**FINAL DRAINAGE REPORT FOR  
WATERBURY FILING NO. 1  
EL PASO COUNTY, COLORADO**

**PUDSP-21-005 & SF237**

**OCTOBER 2024**

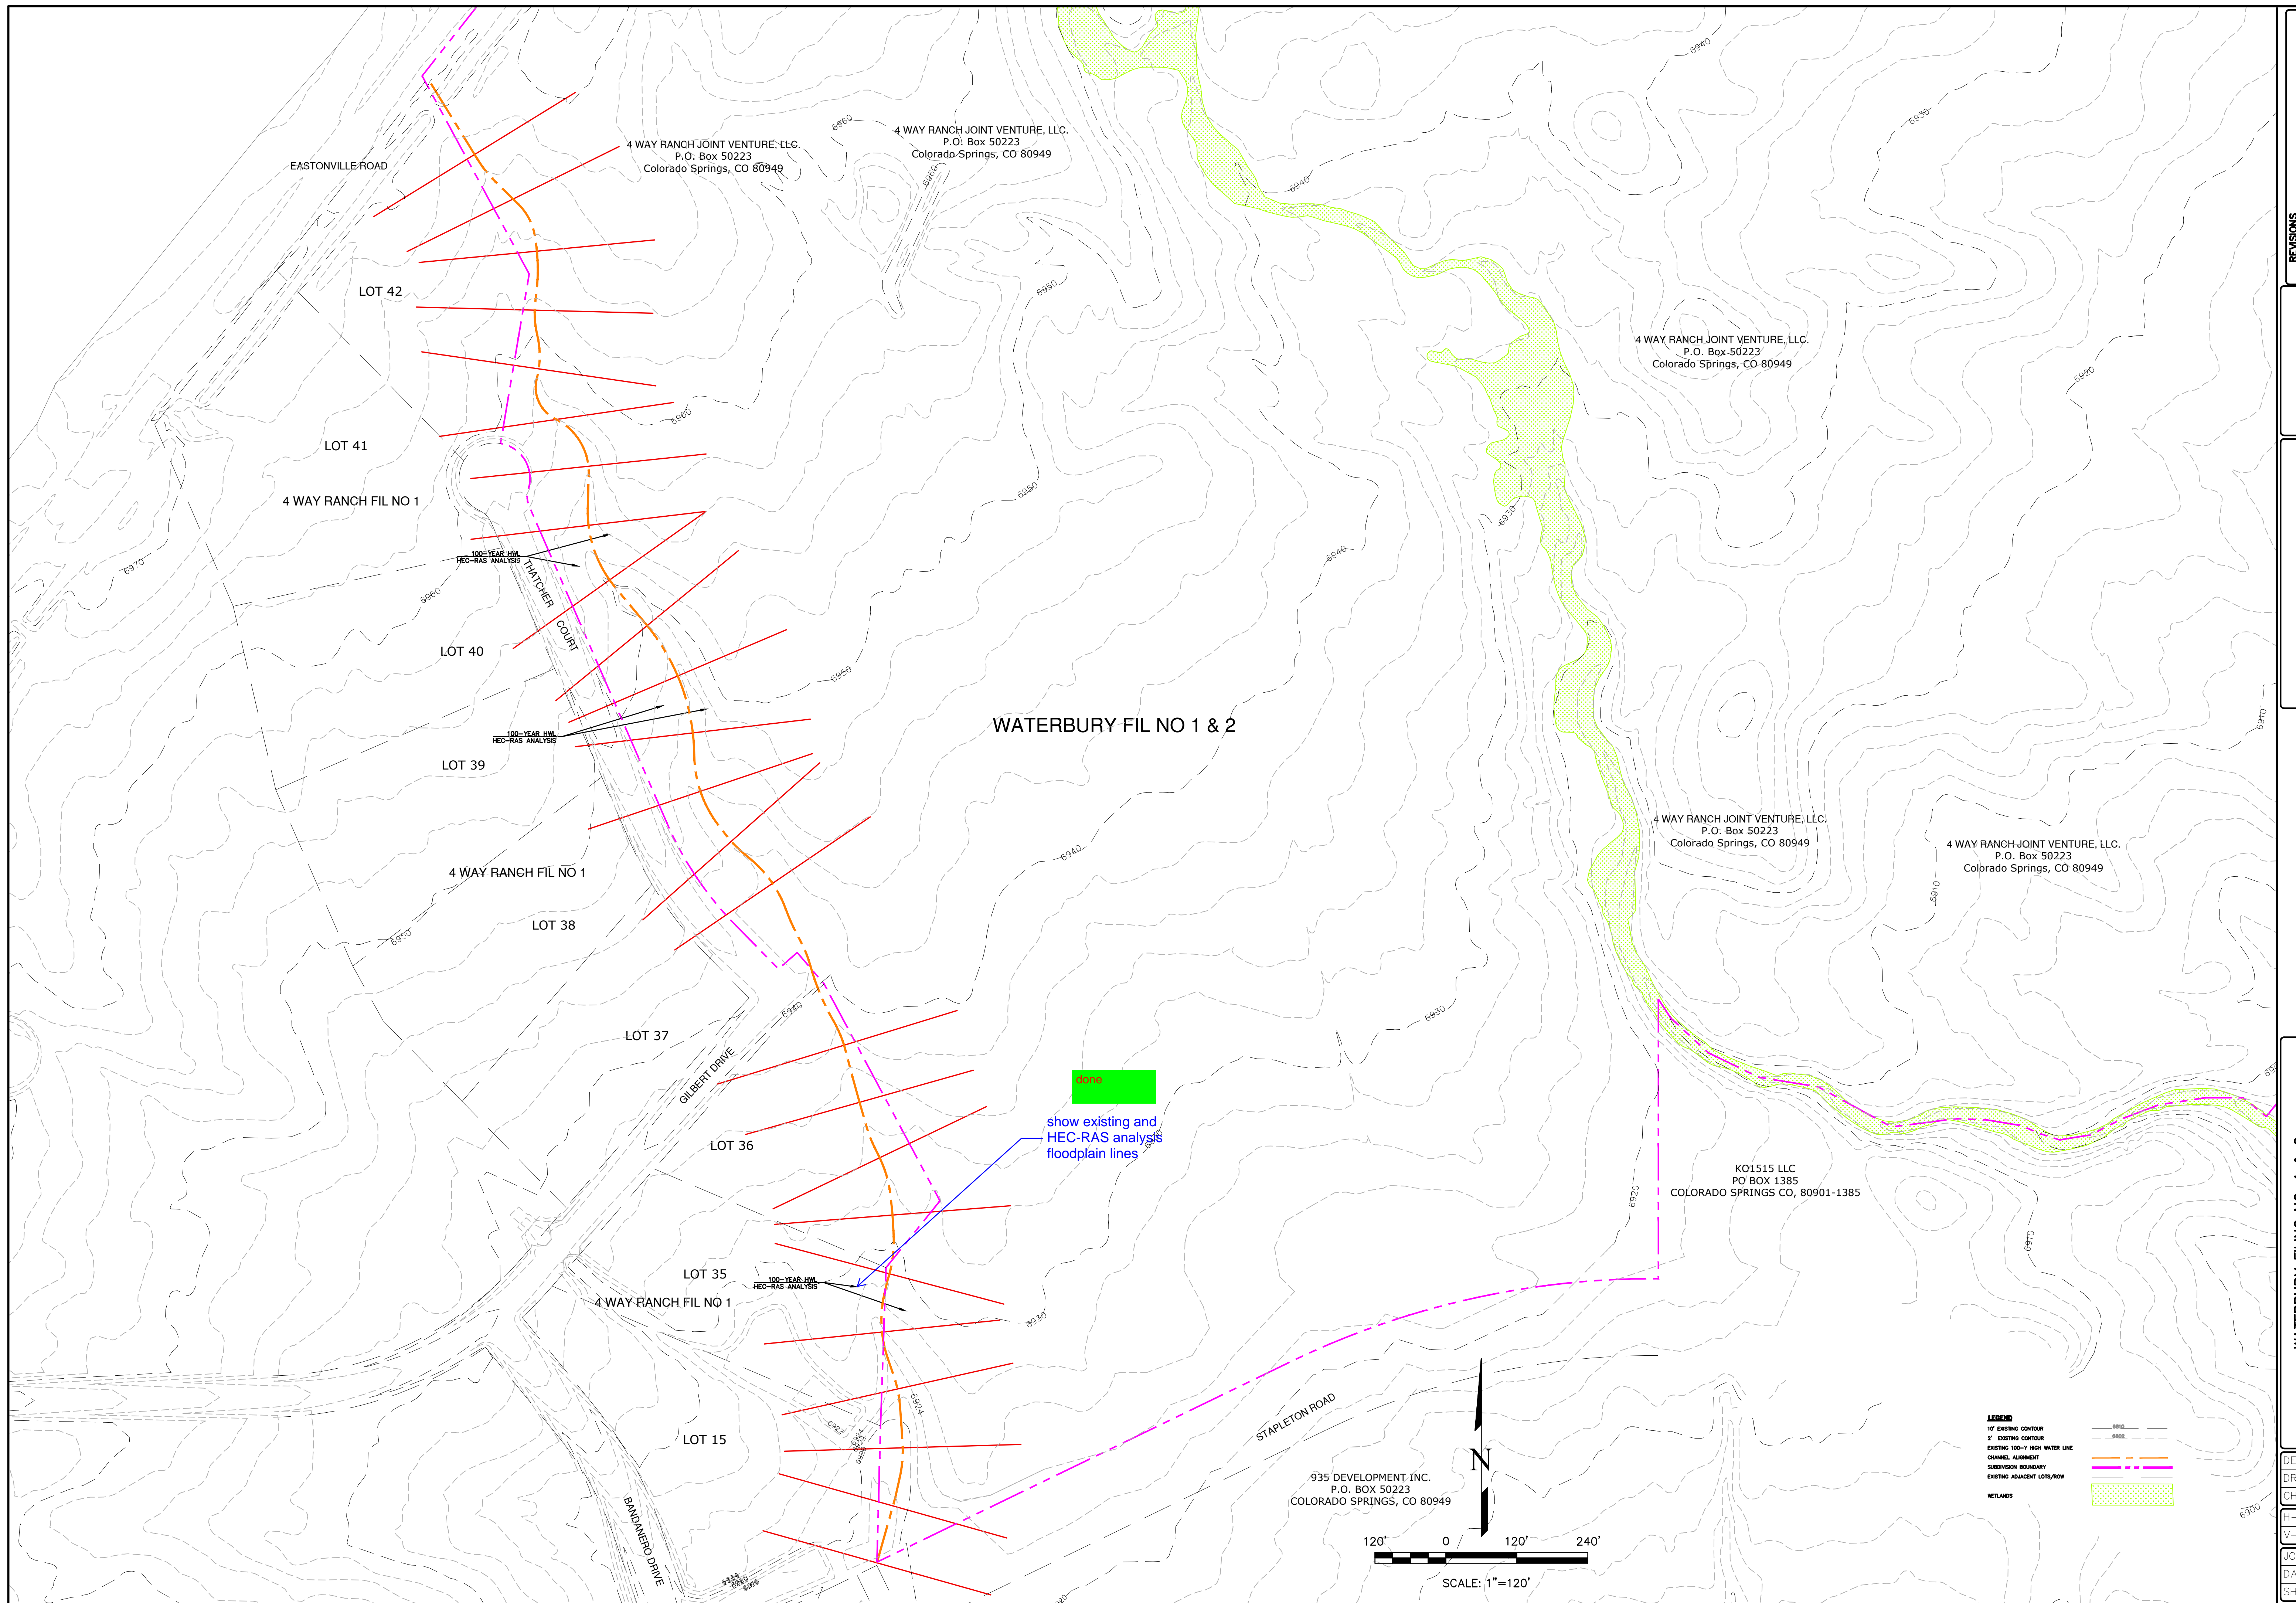
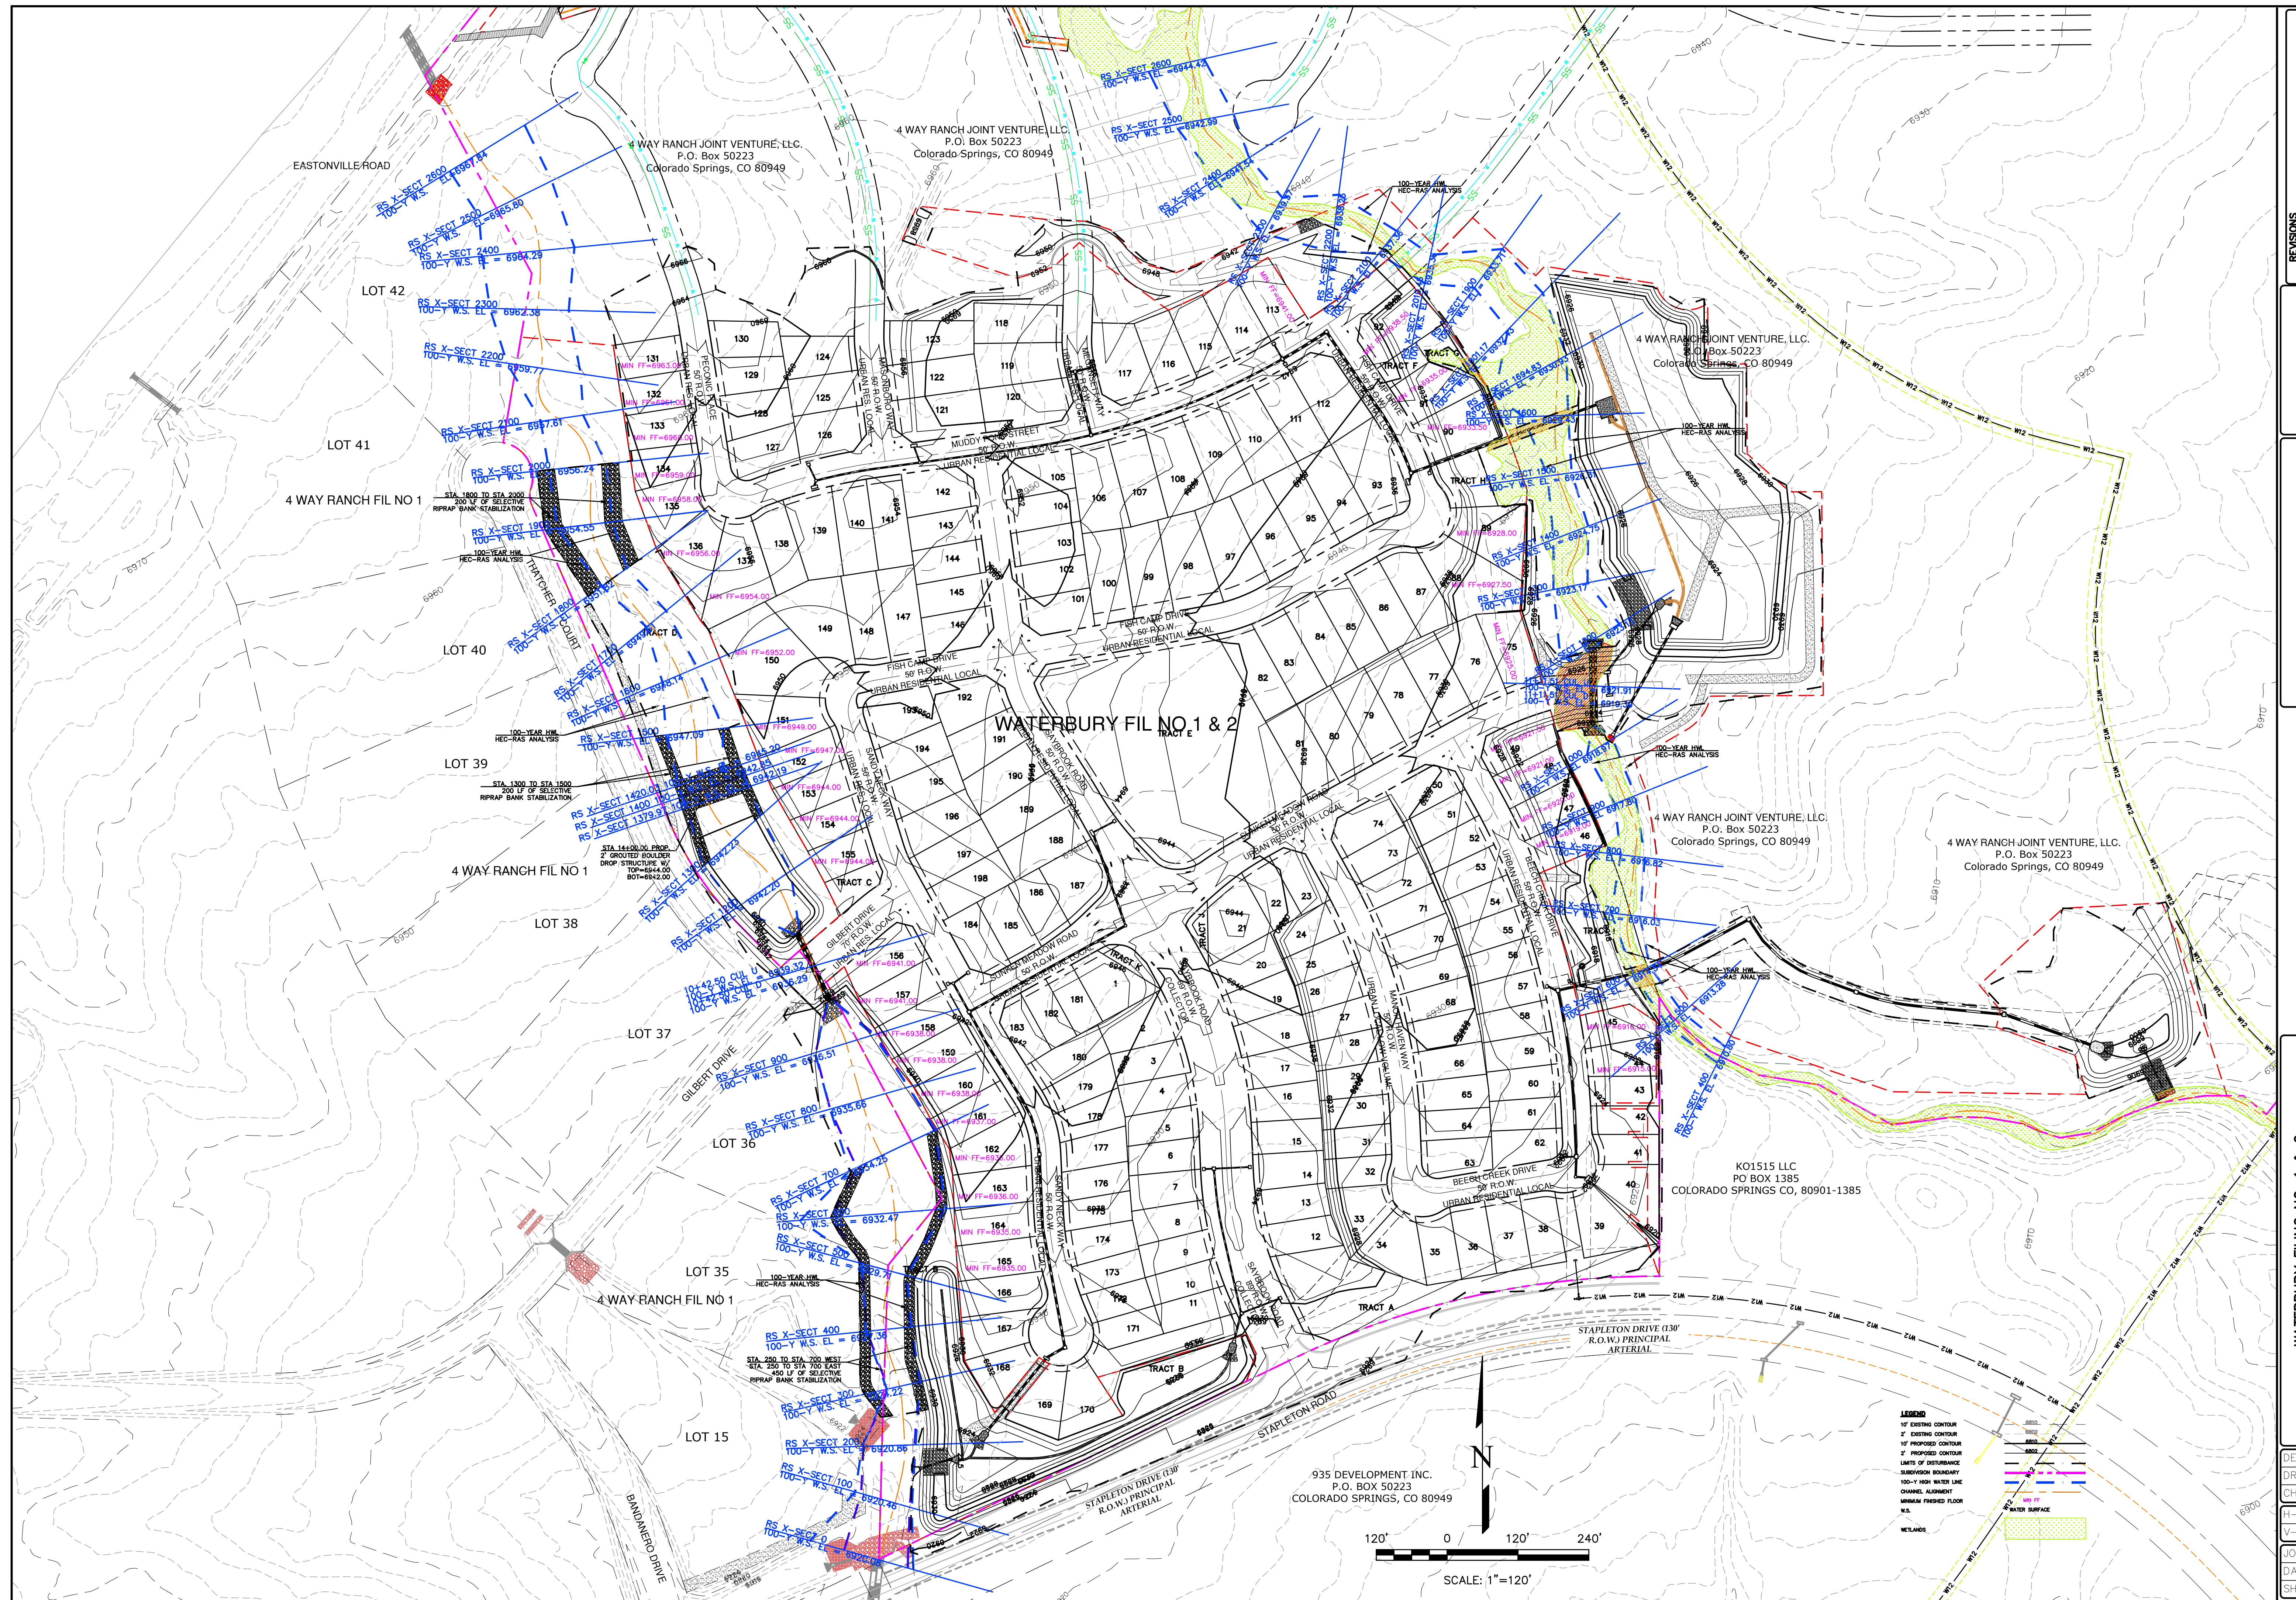
Done  
 show existing and HEC-RAS analysis floodplain lines
